From:
Monks Orchard Residents' Association
Planning

10th January 2019
Emails: planning@mo-ra.co
chairman@mo-ra.co
hello@mo-ra.co

Reference: 18/06070/FUL
Application Received: Mon 17 Dec 2018
Application Validated: Mon 17 Dec 2018
Address: 9A Orchard Rise Croydon CR0 7QZ
Proposal: Demolition of the existing house and office and erection of a two-storey apartment block comprising 4no. two-bedroom apartments and 5 three-storey. three-bedroom houses, together with associated access and parking.
Case Officer: Christopher Grace
Consultation Close Wed 30 Jan 2019

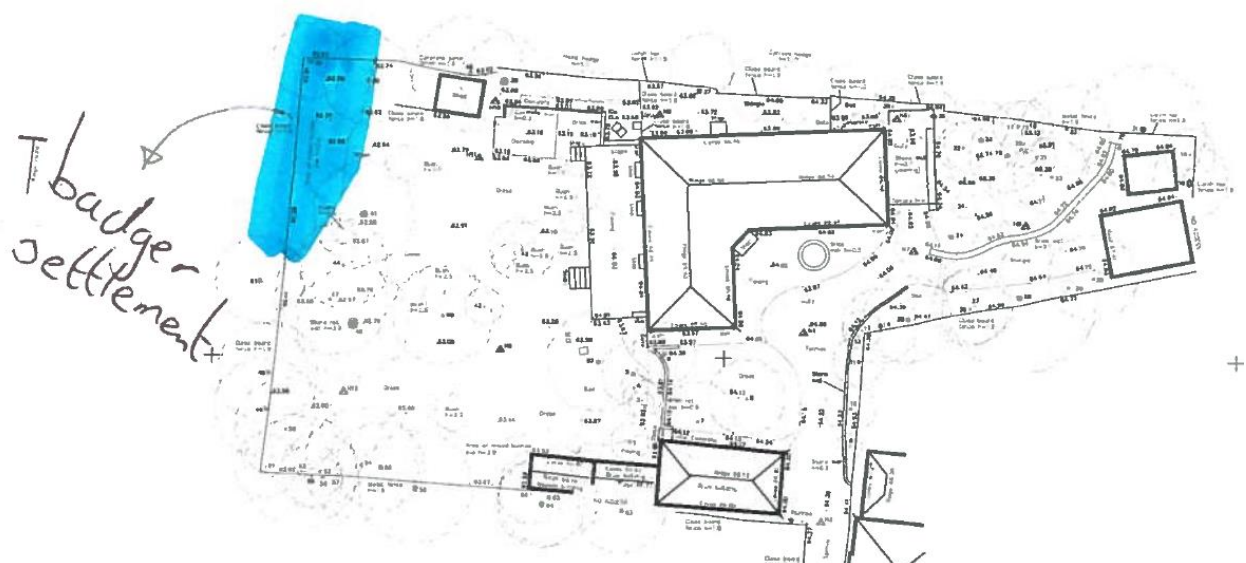
It is known that the site has in the past attracted **Badgers** and a **Badger Sett** has been established in the Northwest corner of the proposed site (shown Blue on the attached diagram) and it is possible that **“Bats”** have habitats in the locality.
